## CD009 Sequential Cam Installation

This upgraded shift cam will decrease shift effort by around 15% and prevent over rotation of the selector shaft that some gearboxes experienced. This is done by eliminating the dwell in the centre of travel a feature that had been introduced for earlier t56 variants of the shifter that required this.

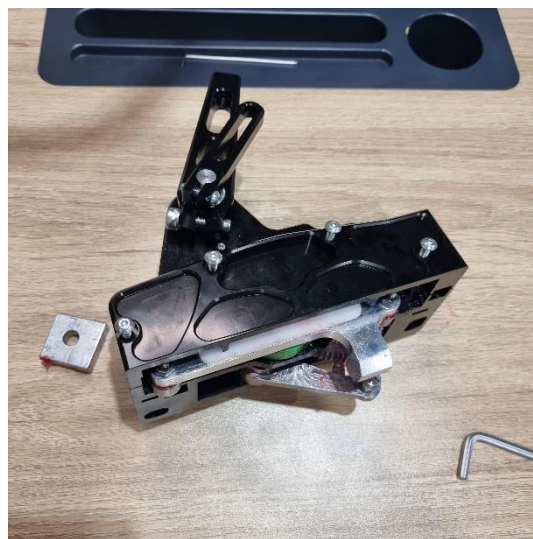
The Revised cam identified below can be recognised by the small drill mark

3. Undo cam using a piece of aluminium to stop rotation of the cam. Do not use the internal parts of the shifter to stop rotation and please use a proper hex tool to do this and not an allen key as the bolt will be very tight.

4. Fit new cam using an aluminium block to prevent rotation again and tighten bolt, Care must be taken to have the cam mounted in the same position as it originally was. If this shifter is in first gear the high lift part of the cam should be facing the rear of the shifter.
